RPA STAFF RECOMMENDATION

Subdivision Case Number:	2016-007	PC Meeting Date: 01-11-16
Subdivision Name:	Eagle Bluff Woods Lots 1 thru 24	
Applicant Request:	Preliminary Plat	
Property Location:	River Run Drive	
Property Owner:	Dr. Sarath Gangavarapu	
Applicant:	Copp Engineering	
Total Acreage:	17.59 Acres	
Proposed Density:	1.42 dwelling units per acre	
Tax Map Number:	102I-D-006	
Zoning:	R-2A Rural Residential District	
Staff Recommendation:	APPROVE as a preliminary plat only subject to the following condition: Hamilton County Groundwater Protection review and approval of septic tank use for these proposed lots

PRELIMINARY PLAT

EAGLE BLUFF WOODS

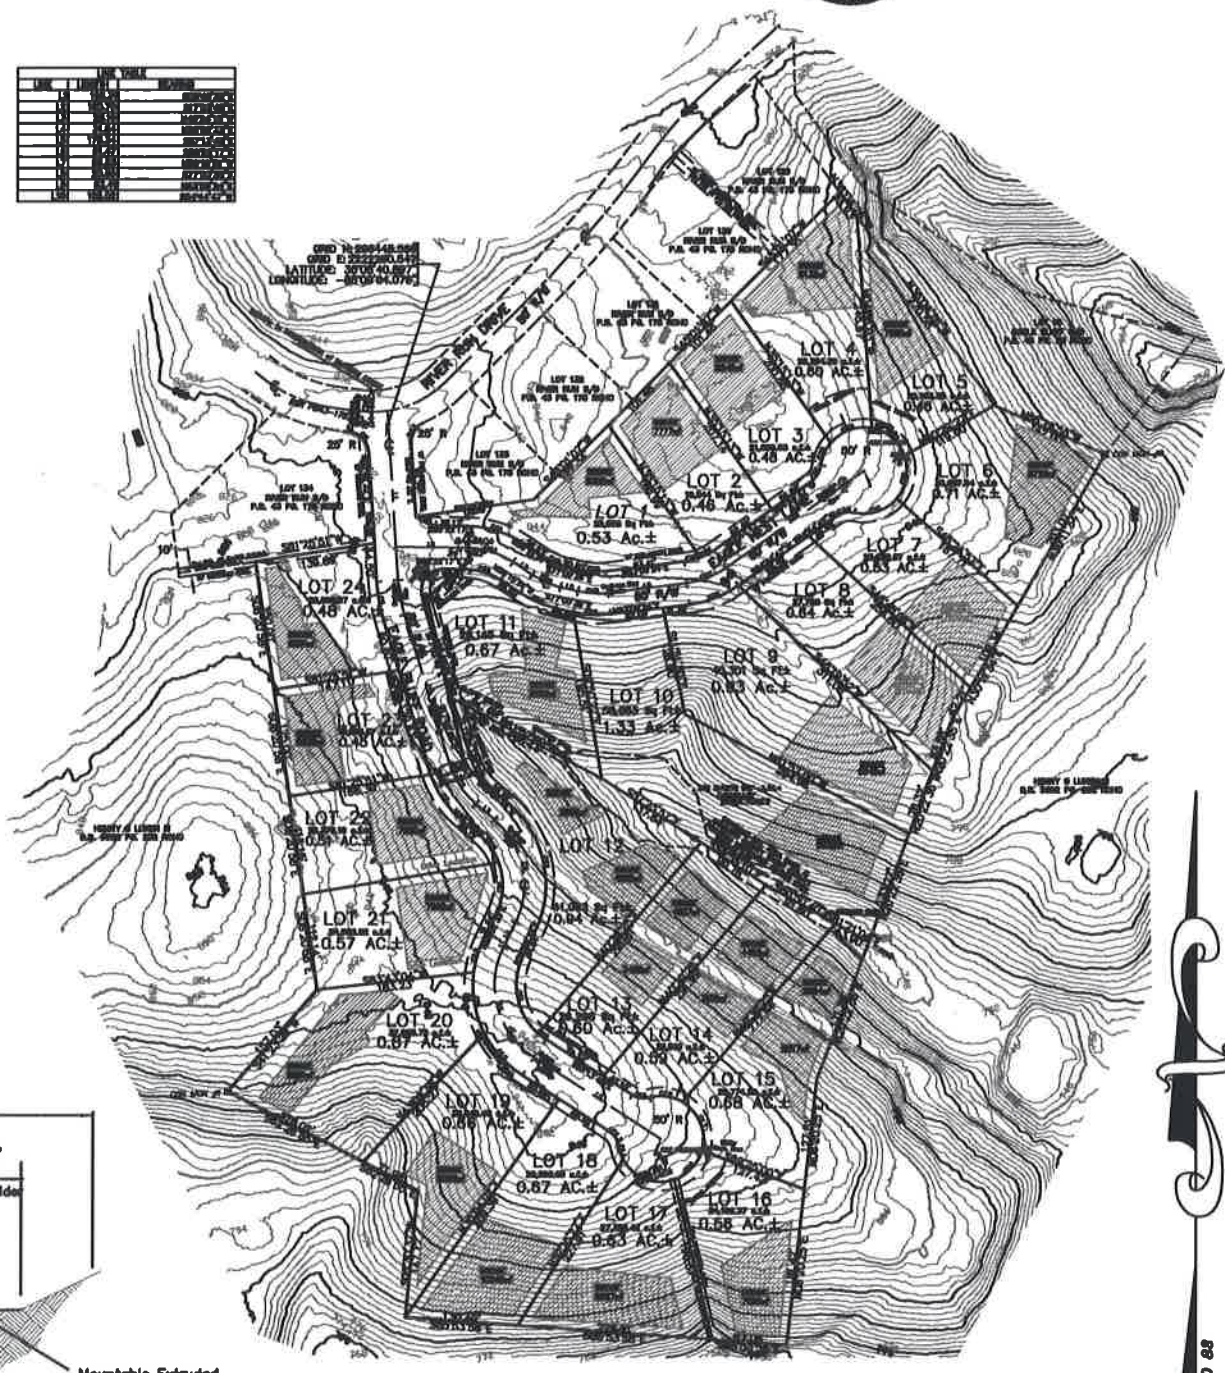
1. Submit drainage calculations for all proposed and existing drainage pipes in the right-of-way that are greater than 15" in diameter.
2. Submit grading/drainage plan for review.
3. A minimum of 8" crushed stone base is required in all new streets.
4. There are no additional comments or requirements from the Hamilton County Engineer's Office as part of the review of this subdivision plat review.
5. Questions about Hamilton County Engineer's office requirements should be directed to Mr. Mike Hendrix at 209-7810.
